Project Name: **BRW&S H2GO Administrative and Field Operations Complex (A+FO Complex)**
Adjacent to 146 Gregory Road, NE
Belville, NC 28451

Architect's Project Number: #342302

ADDENDUM NUMBER ONE

06-A1.01 FIRST FLOOR PLAN-BUILDING 06

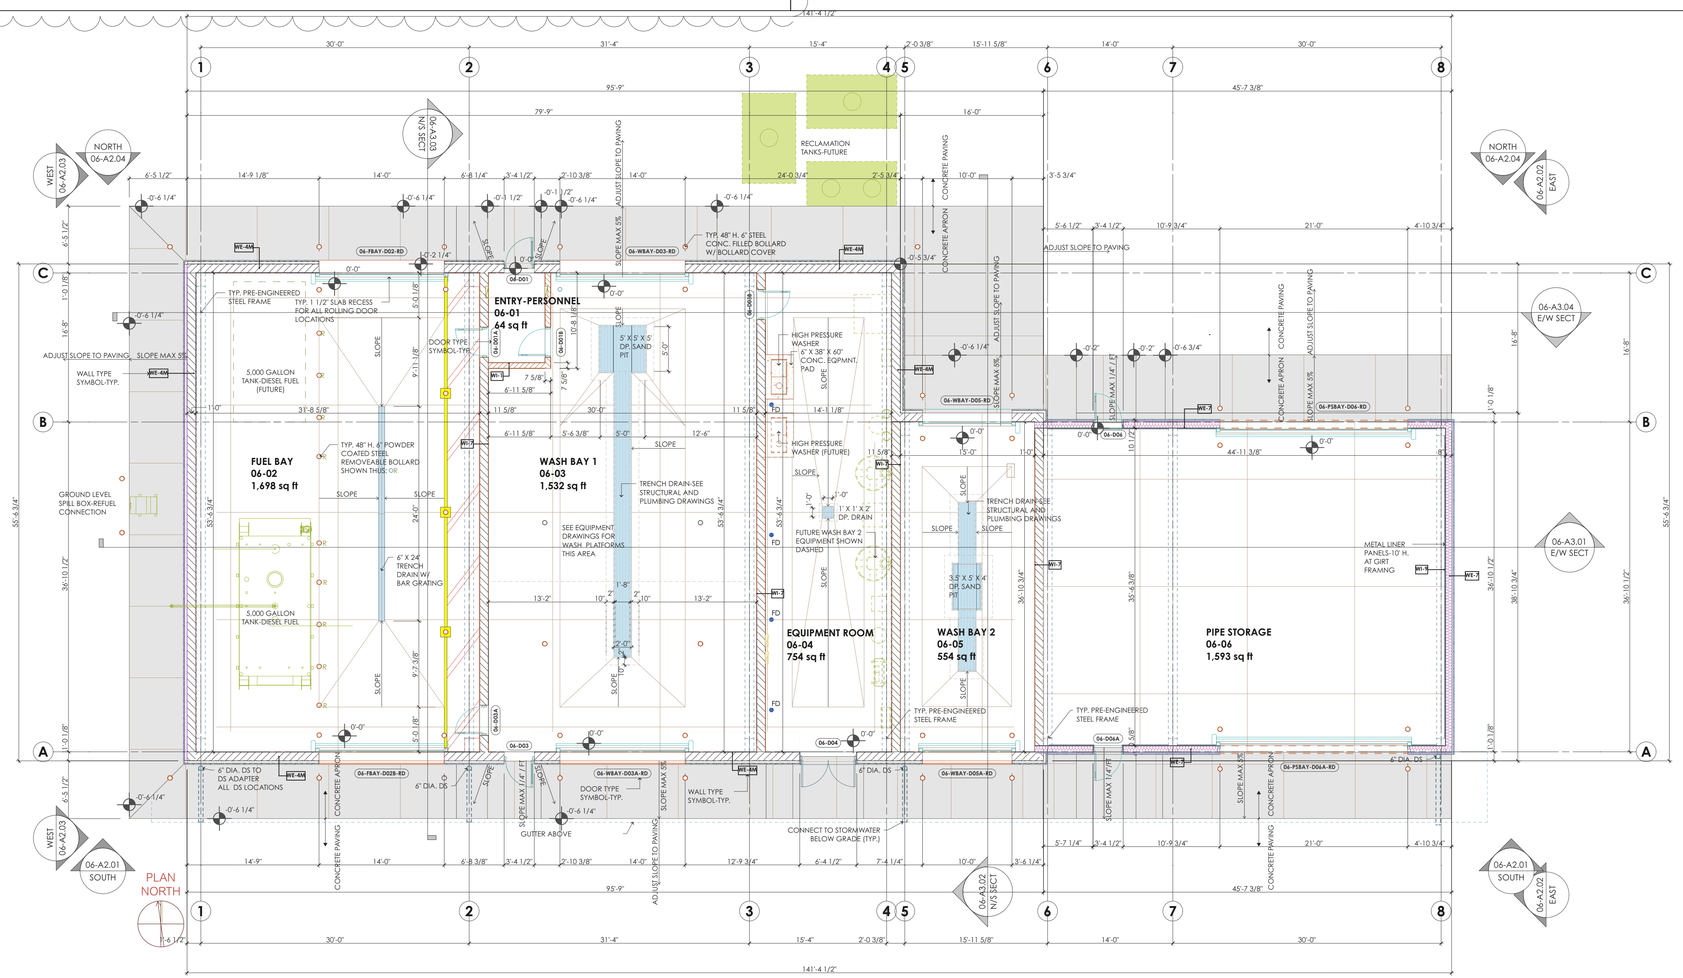
Change 01: Add 06-A1.03 Wall Types Legend.

Change 02: Correct Sheet Number – Change to 06-A1.

- **Sheet 06-A1 First Floor Plan – Finish Schedule:** Revised Sheet Number (ID 02) and Added 06-A1.03 Wall Types Legend (ID 021)

03-FP101

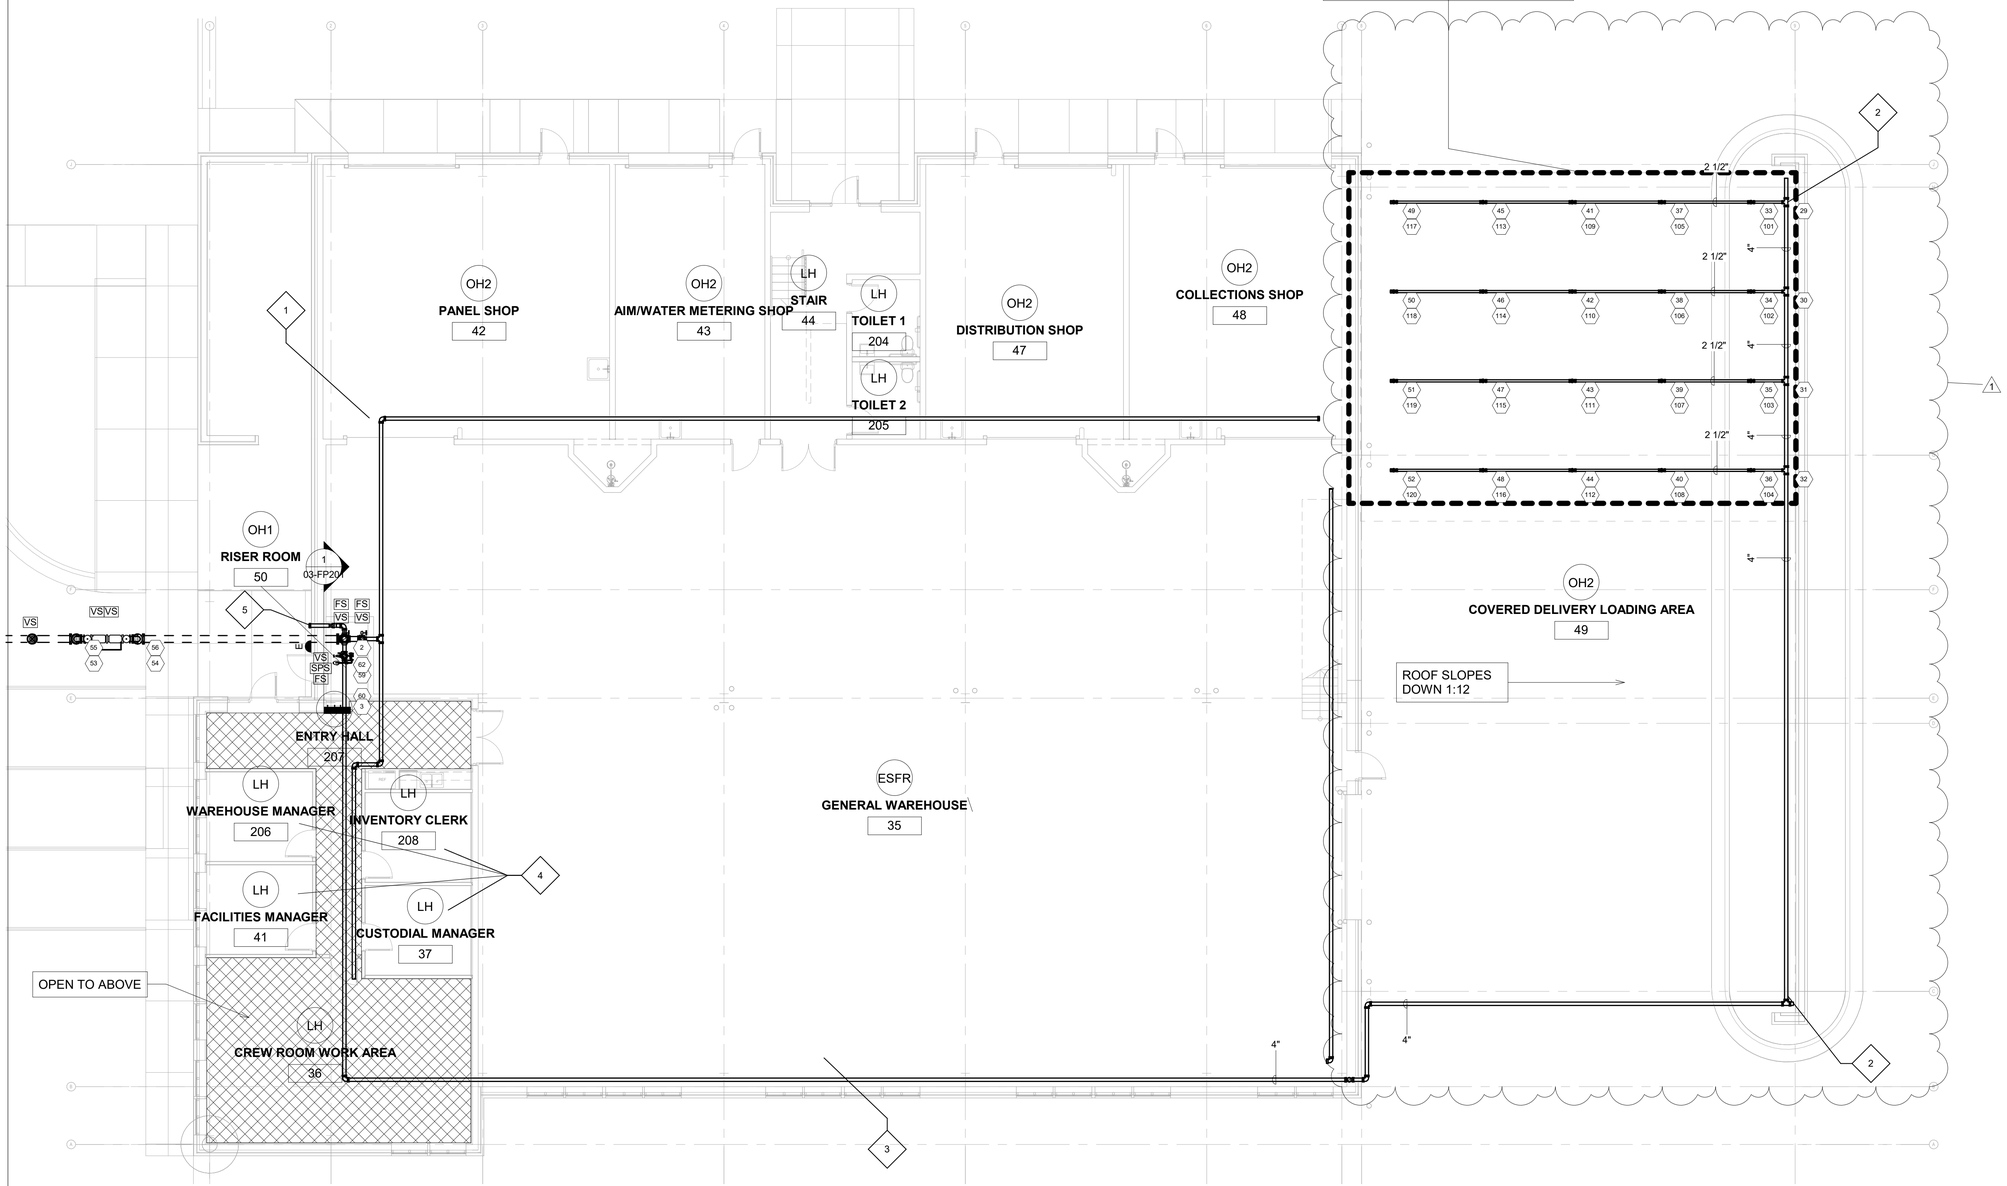
- **Sheet 03-FP001 General Fire Sprinkler Notes:** Updated hydraulic calculation summary table to reflect updated piping layout.
- **Sheet 03-FP101 Level 1 Fire Sprinkler Plan:** Updated piping layout for dry system.
- **Sheet 03-FP102 Mezzanine Fire Sprinkler Plan:** Updated piping layout for sprinkler system and hydraulic remote area table. Added tags to sprinkler main pipe sizes.
- **Sheet 03-FP201 Fire Sprinkler Riser:** Added pipe size dimension tags.

D. **Drawing Sheet 03-FP101 Dry System / Grid System.** The exterior canopy shall be designed per NFPA 13 standards. Updated drawing sheet 03-FP101 is attached showing the updated pipe routing arrangements.

03-FP102

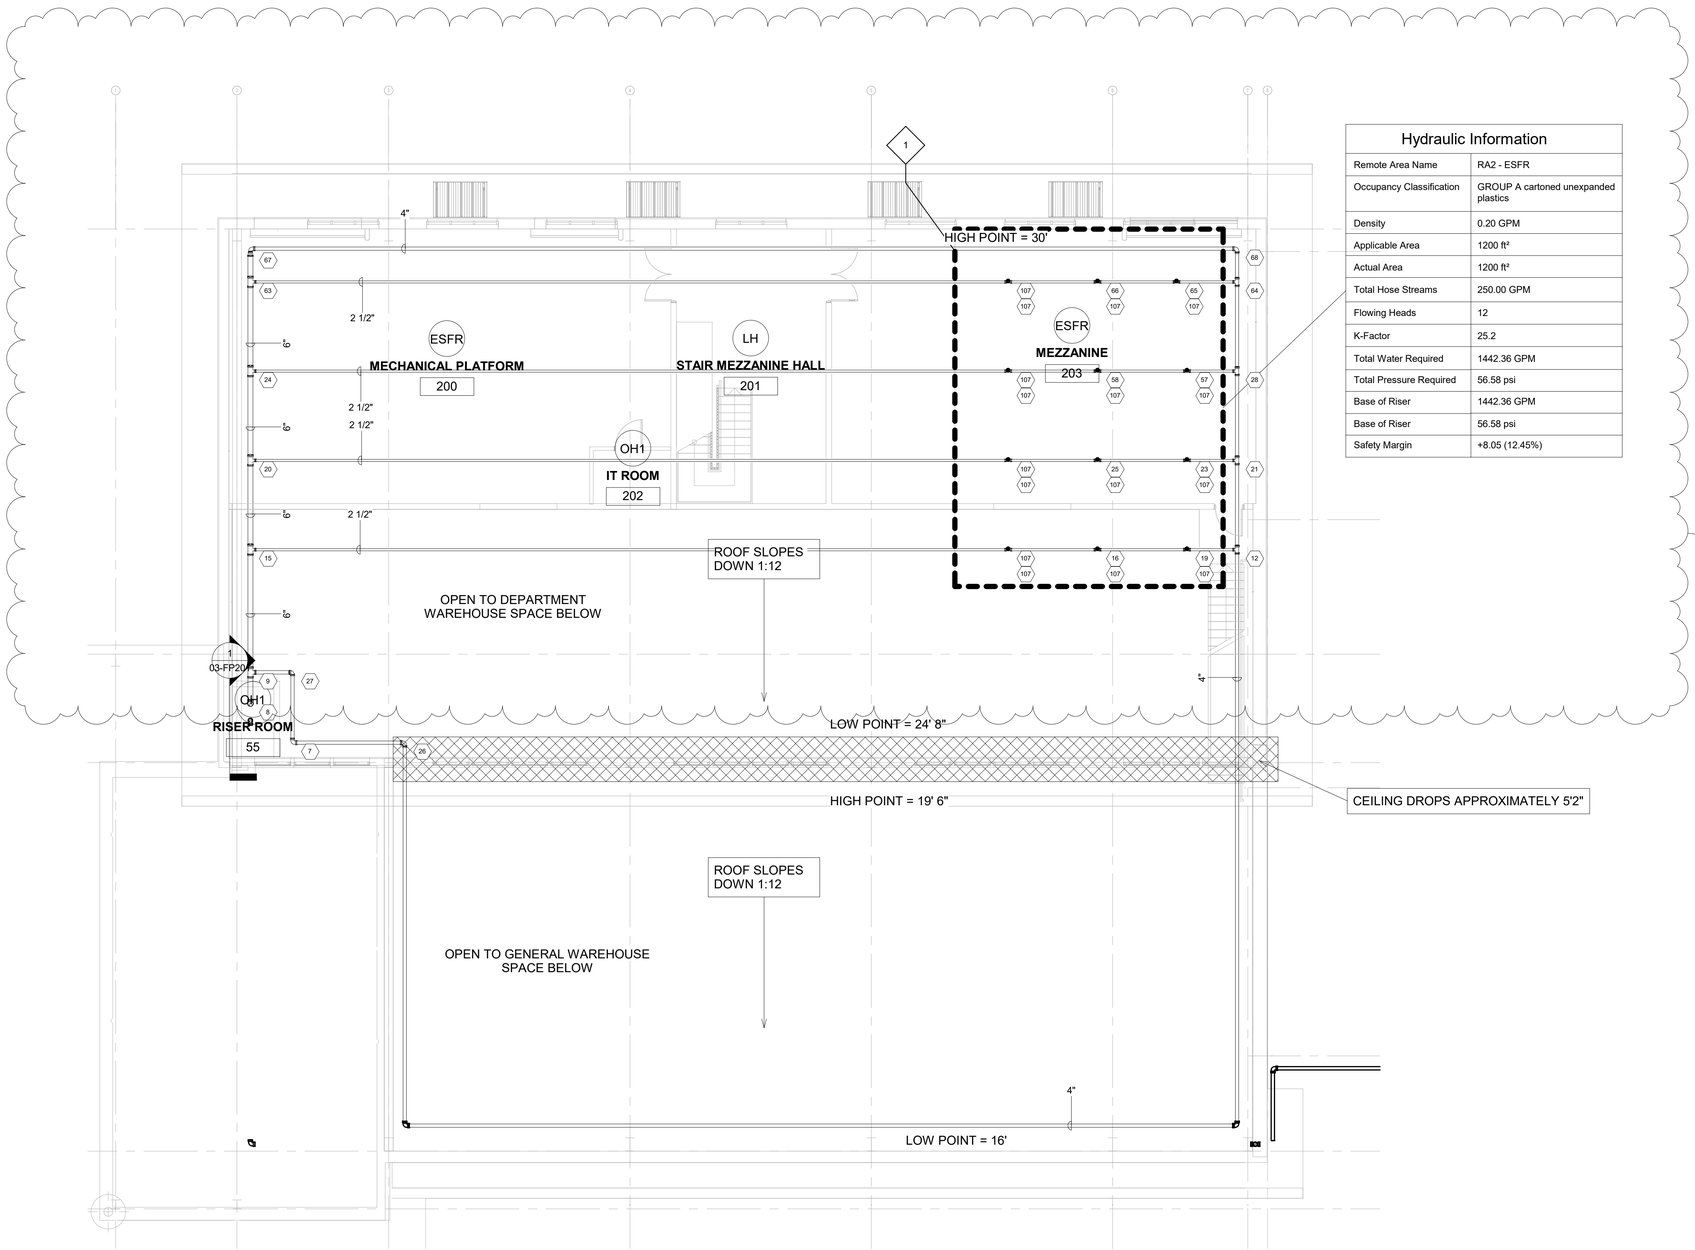
E. **Drawing Sheet 03-FP102 System.** The system was calculated with an 8" underground, a 6" riser and a 4" look with 2.5" branchlines and 1" drops to the sprinklers for performance level design. Updated drawing sheet 03-FP102 showing pipe sizes shown for mains and branchlines is attached.
